PLAN OF PROPOSED IMPROVEMENT

2901 UNIVERSITY AVE
THE QUARRY

CITY PROJECT NO. 11913
CITY CONTRACT NO. 8147

TYPICAL SECTION

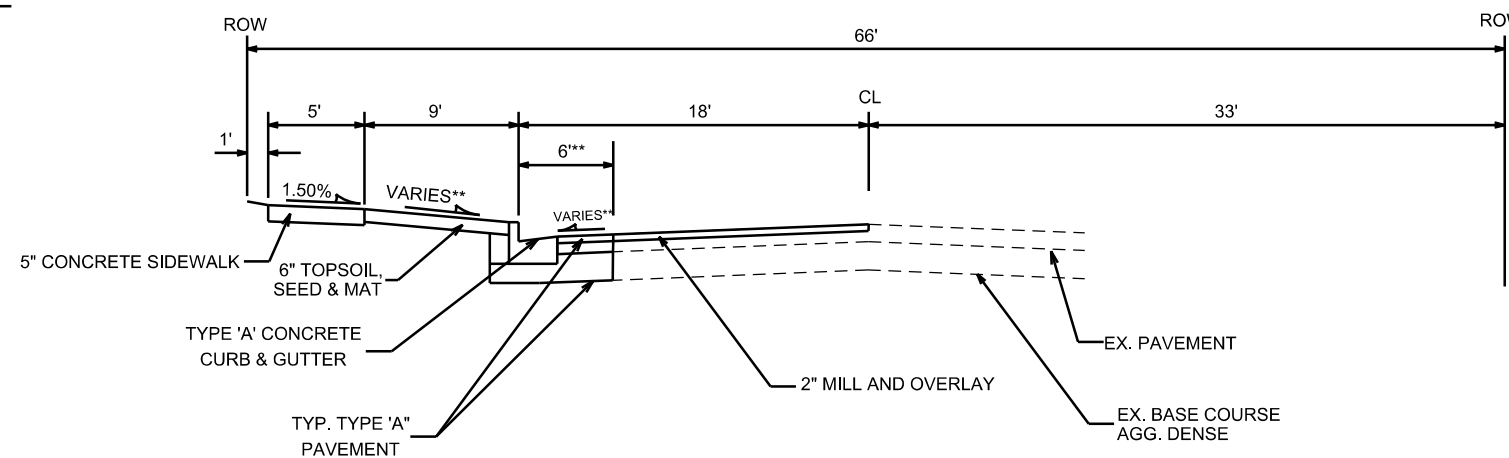
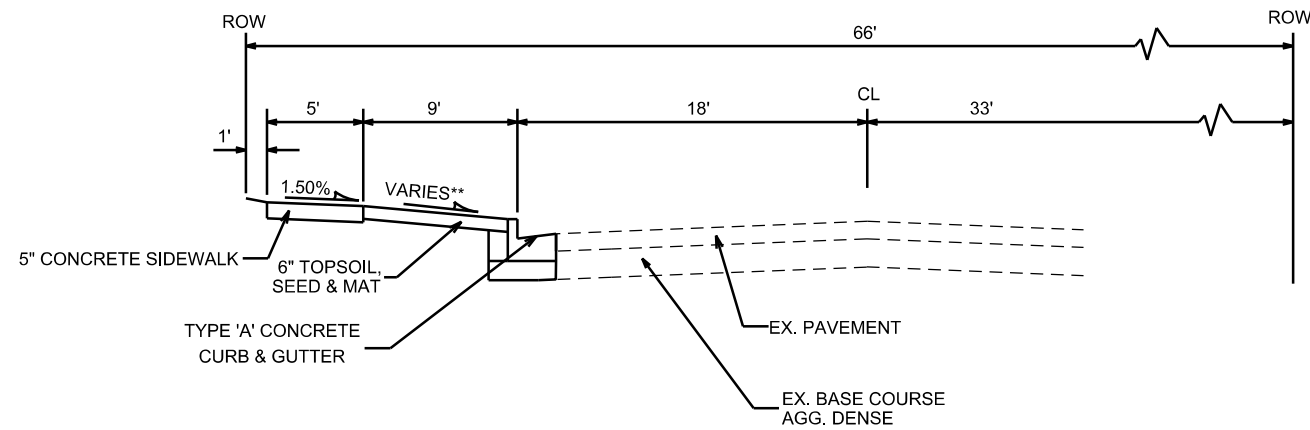
REV. 07/30/2018 **AJM**
**ADDED TWO TYPICAL SECTIONS
TO REPRESENT VARIOUS TYPES
OF WORK REQUIRED FOR THE
CONSTRUCTION OF RIDGE ST.**

TYPICAL SECTION

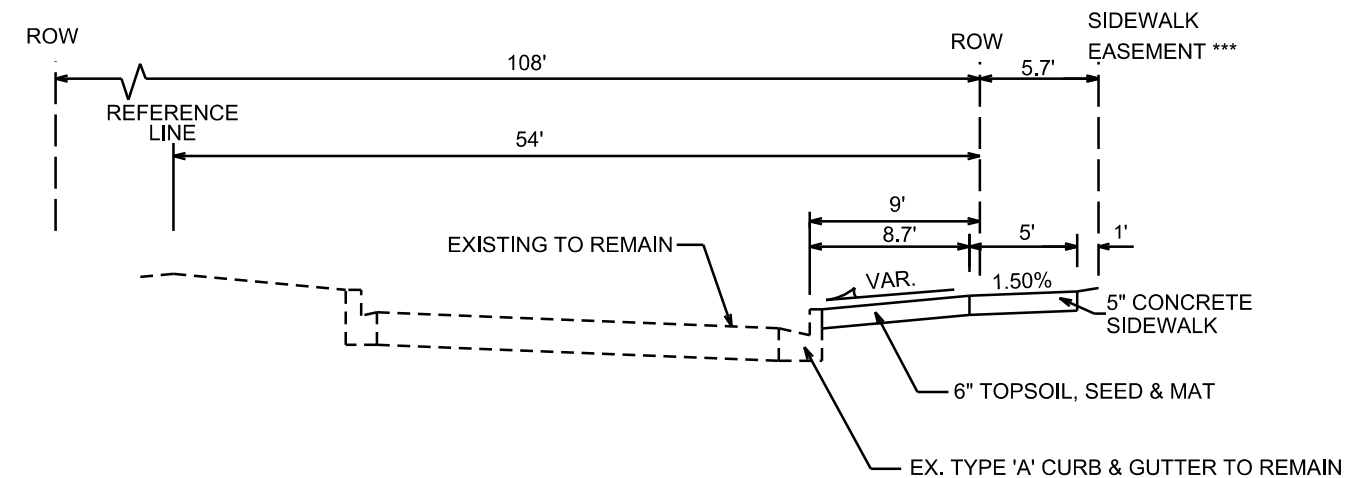
HARVEY AND UNIVERSITY TYPICAL SECTIONS MOVED TO ANOTHER SHEET

SIDWALK PLAN AND PROFILE
RIDGE ST CITY OF MADISON

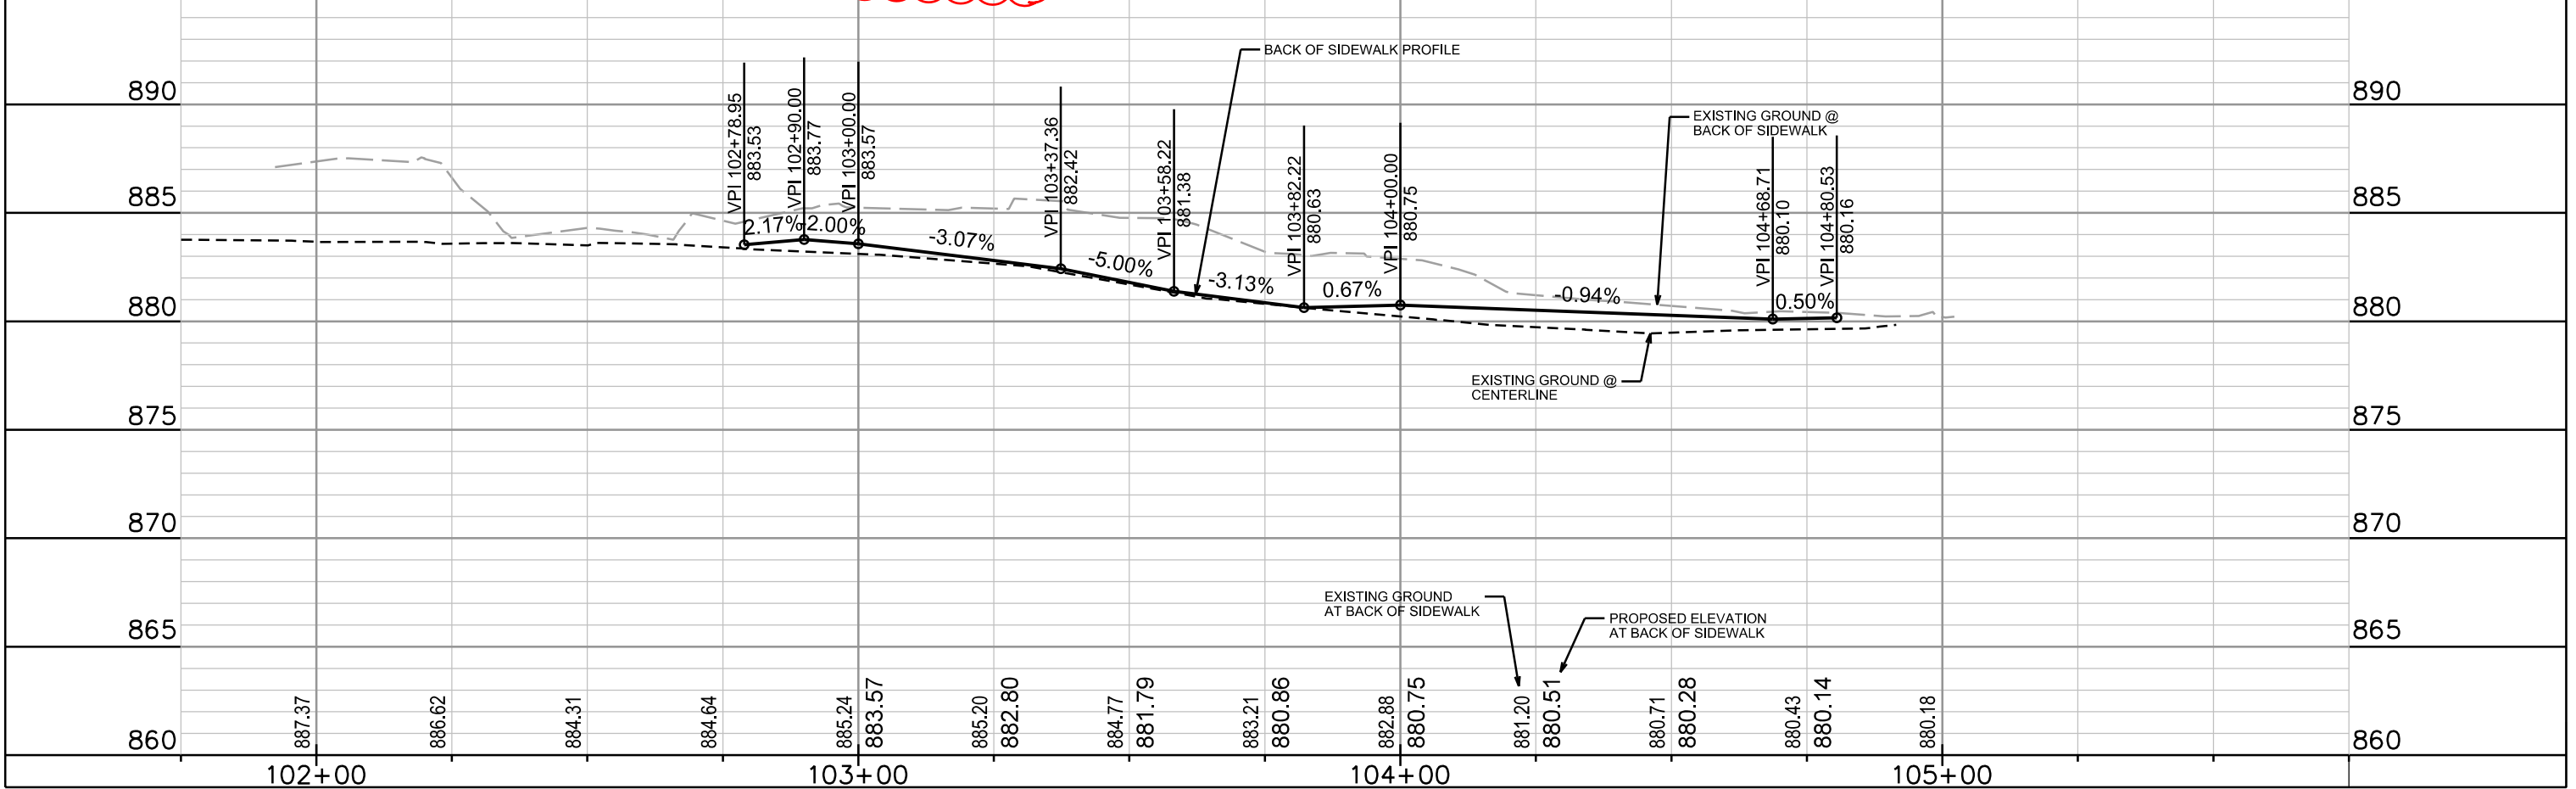
REVISED: 07/30/2018
**FULL DEPTH ROAD RECONST.
LIMITS REDUCED TO A MILL
& OVERLAY SECTION (SHOWN
AS HATCHED PATTERN)**

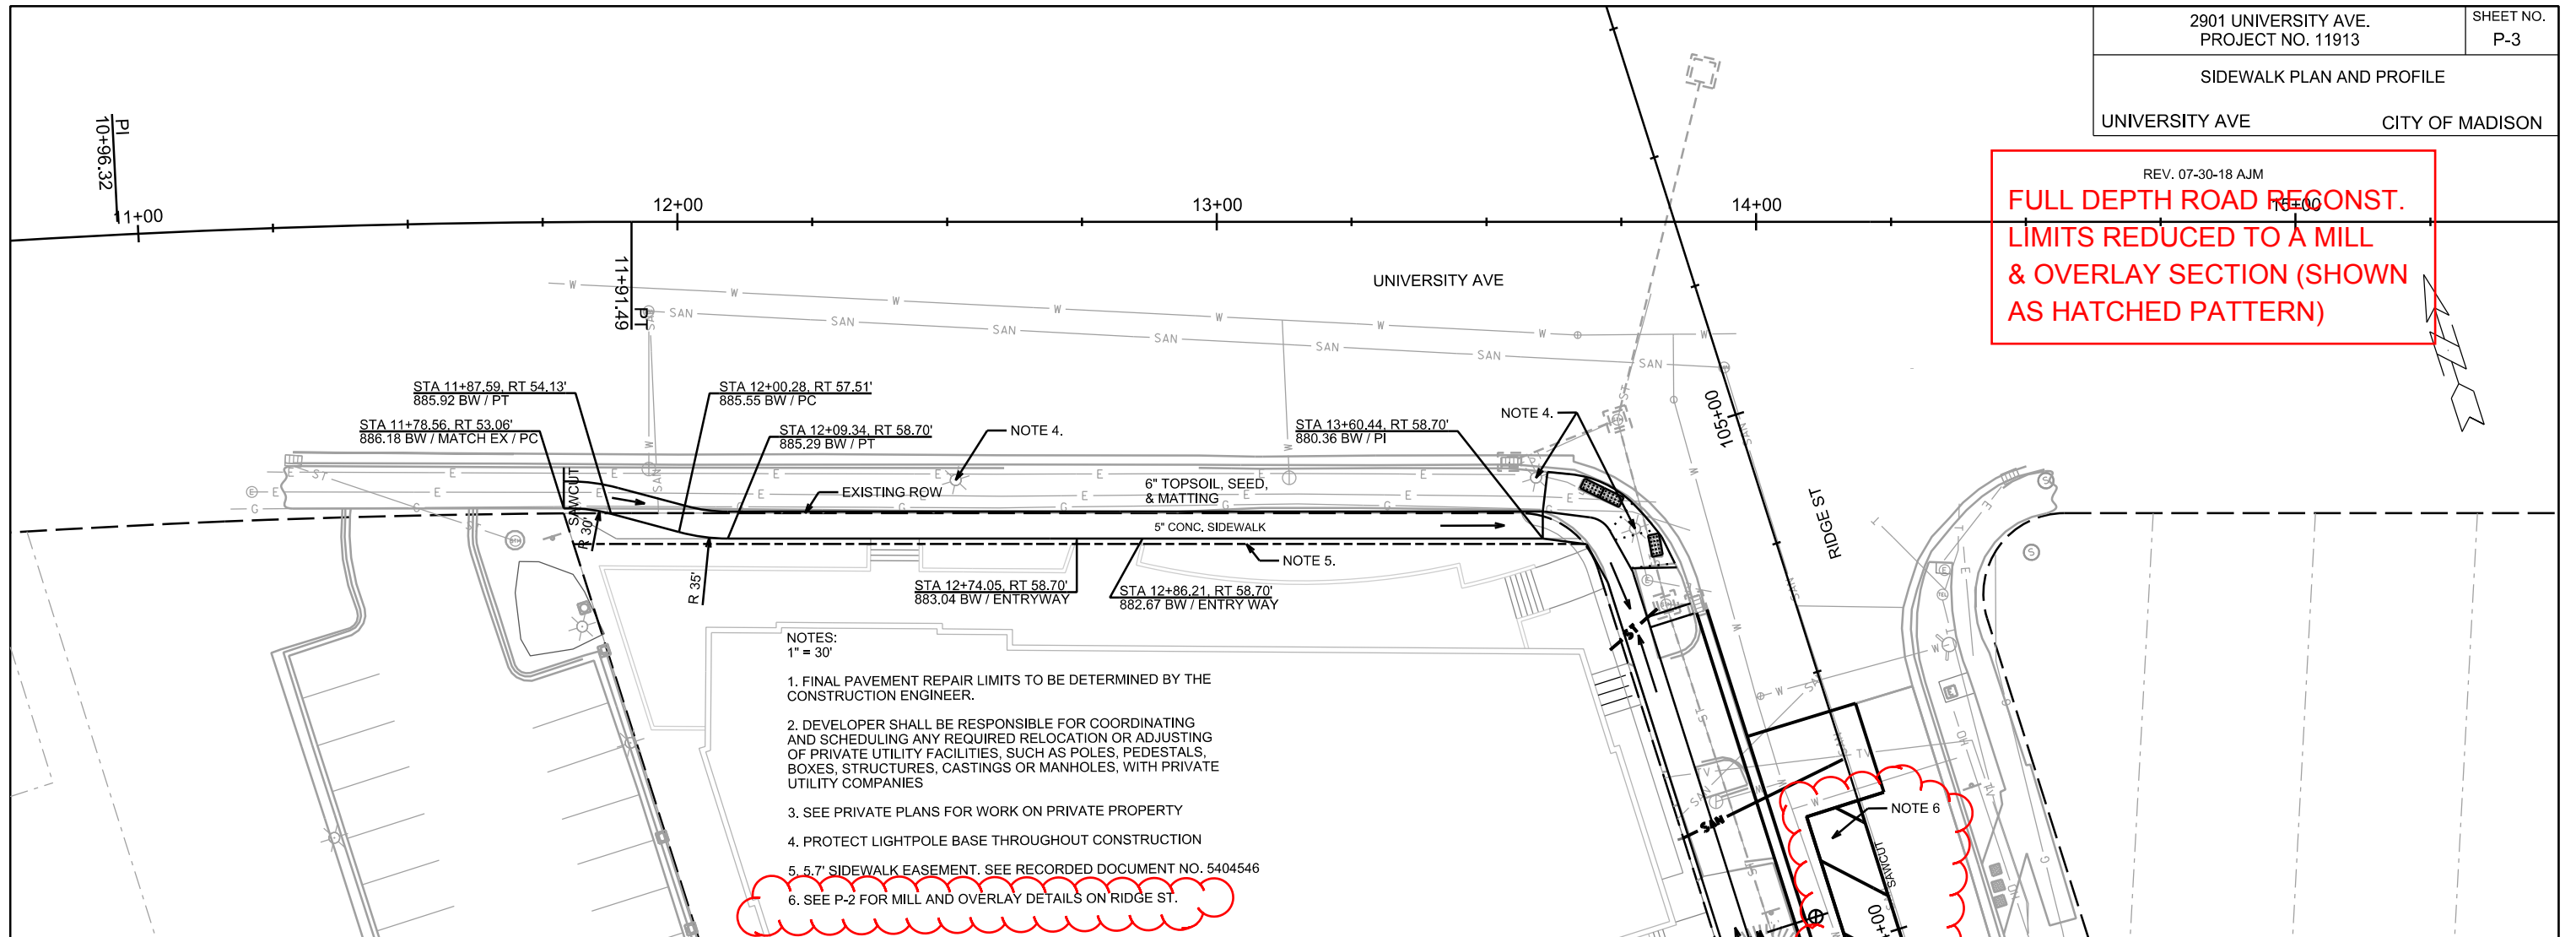
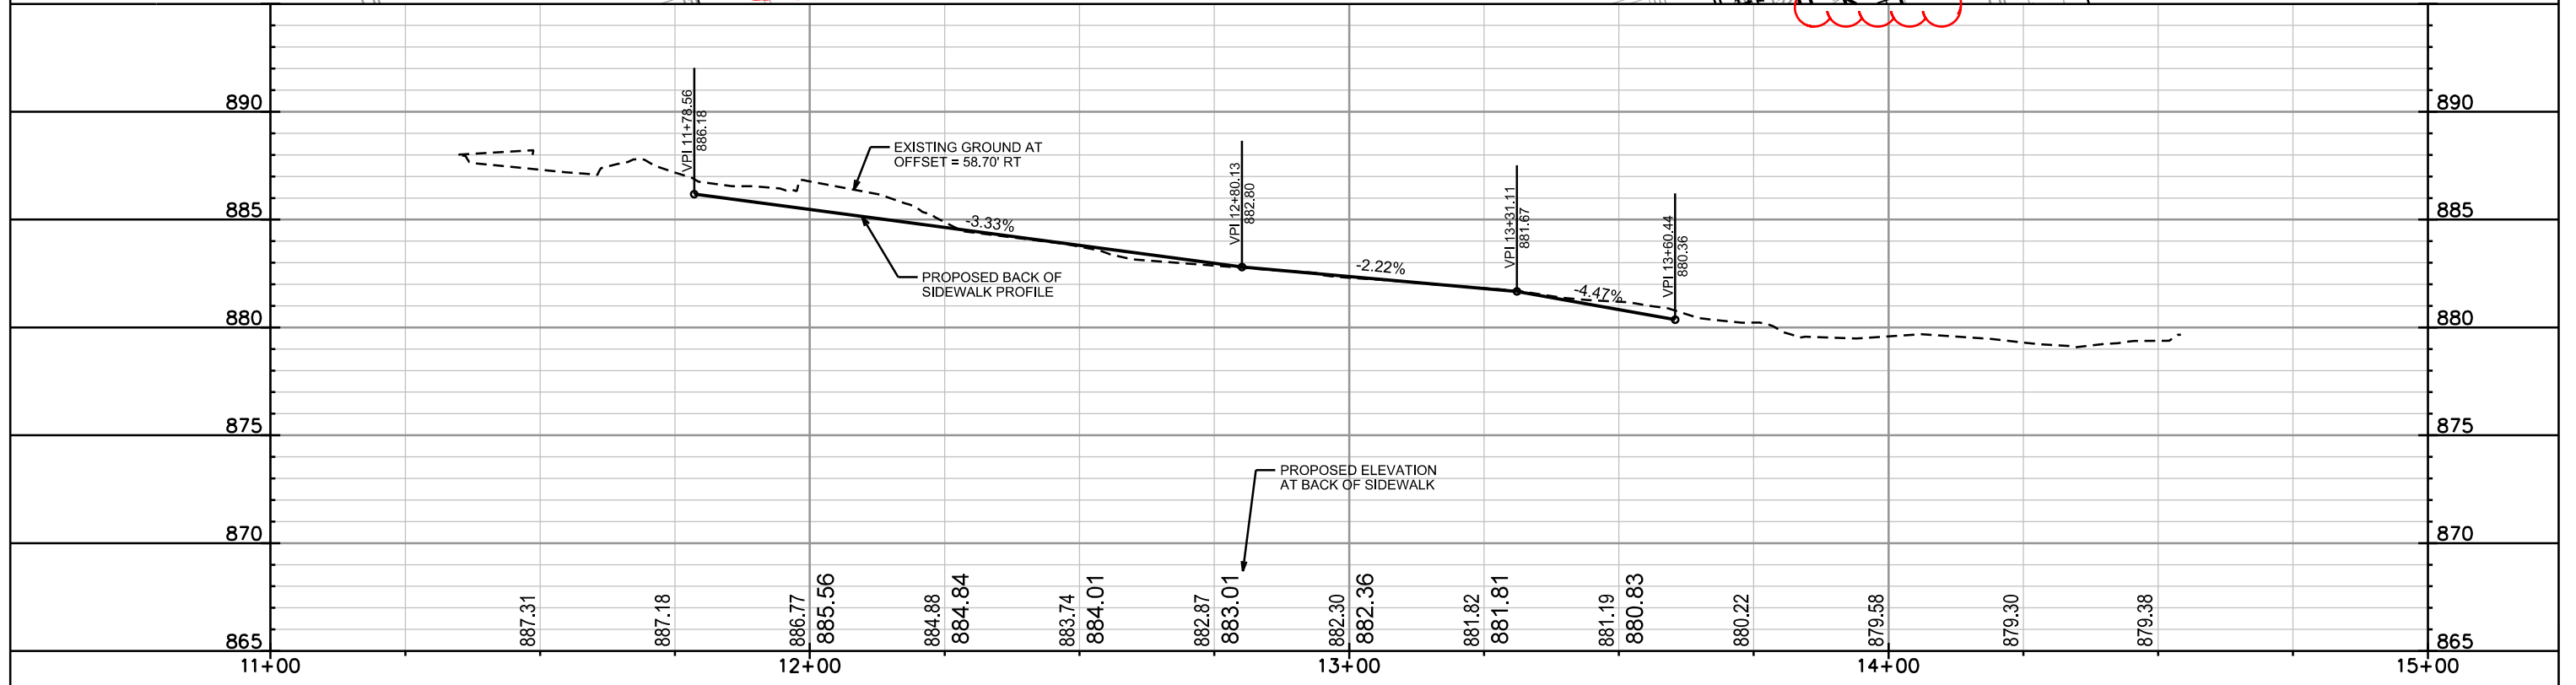
**FULL DEPTH ROAD RECONST.
LIMITS REDUCED TO A MILL
& OVERLAY SECTION (SHOWN
AS HATCHED PATTERN)**
